NUMBER: 08-002-05

Headlamp Condensation

This bulletin involves improving the headlamp housing ventilation by installing new style vents and plugs.

2004 - 2005 (ZH) Crossfire Coupe/Crossfire Roadster

Fig. 1 HEADLAMP HOUSING IN VEHICLE

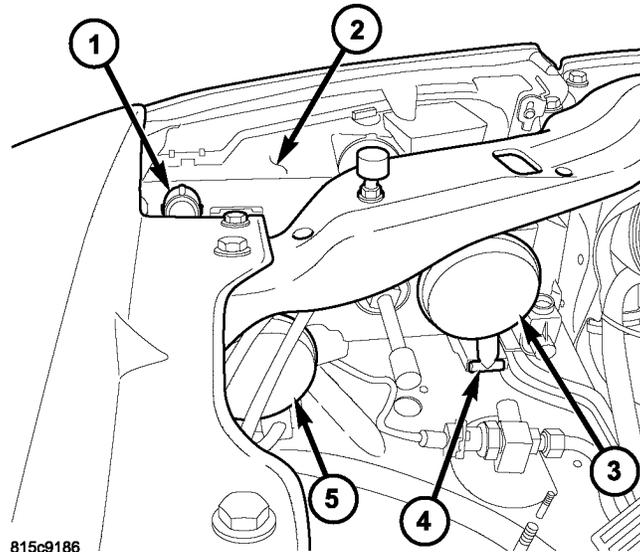
1. Open the hood.
2. Install a battery charger and verify that the charging rate provides approximately 13.5 volts.
3. Remove the vent hoses and the rubber caps from the **both** headlamp housings (Fig. 1).

-
4. Turn on the headlamps, including the high beams. Allow the headlamps to remain on for a minimum of 45 minutes or until the headlamp housings dry out. When both headlamp housings are dry, proceed to the next step. **The headlamps are to remain "On" until Step #9.**
 5. Beginning on the left side of the vehicle, install two of the small rubber plugs from the new seal kit; on the headlamp housing where the vent hoses were previously removed, (#1 & #4) (Fig. 1).

- 6. Install the new rubber cap with the special vent on the large inboard hole in the headlamp housing (Fig. 1).
- 7. Install the large rubber cap that was removed in Step #1 on the large outboard hole in the headlamp housing (Fig. 1).
- 8. Repeat Step #5 through Step #8 on the right side of the vehicle. When Step #5 through Step #8 have been completed on both sides of the vehicle, proceed to the next step.

Fig. 2 HEADLAMP HOUSING PRIOR TO REPAIR PROCEDURE

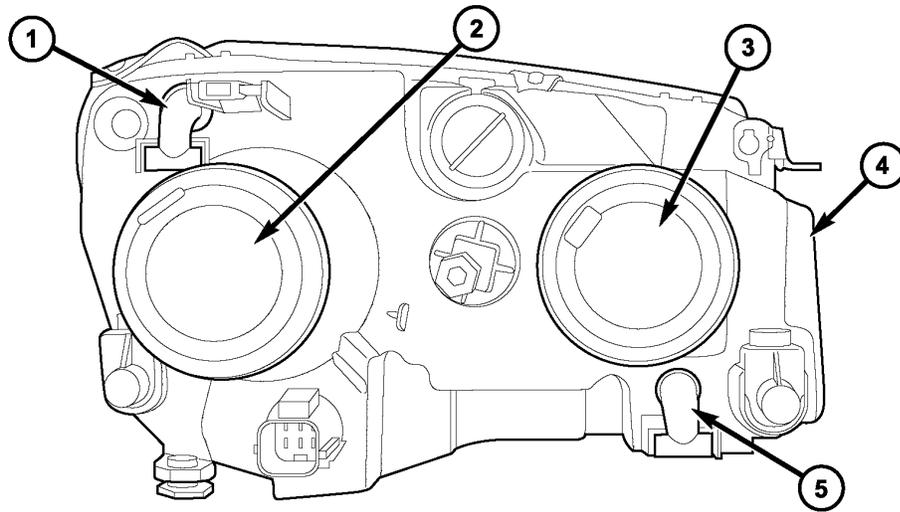
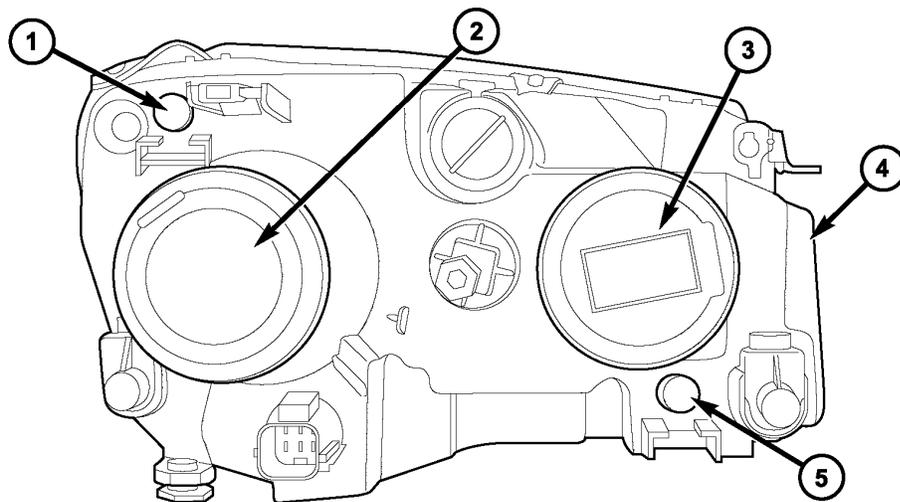
- 1 - UPPER HEADLAMP VENT (DISCARD)
 - 2 - LARGE OUTBOARD RUBBER CAP (REUSE)
 - 3 - LARGE INBOARD RUBBER CAP (DISCARD)
 - 4 - LEFT HEADLAMP HOUSING
 - 5 - LOWER HEADLAMP VENT (DISCARD)
-

- 1 - NEW SMALL RUBBER PLUG
 - 2 - ORIGINAL LARGE OUTBOARD RUBBER CAP
 - 3 - NEW LARGE INBOARD RUBBER CAP WITH SPECIAL VENT
 - 4 - LEFT HEADLAMP HOUSING
 - 5 - NEW SMALL RUBBER PLUG
-
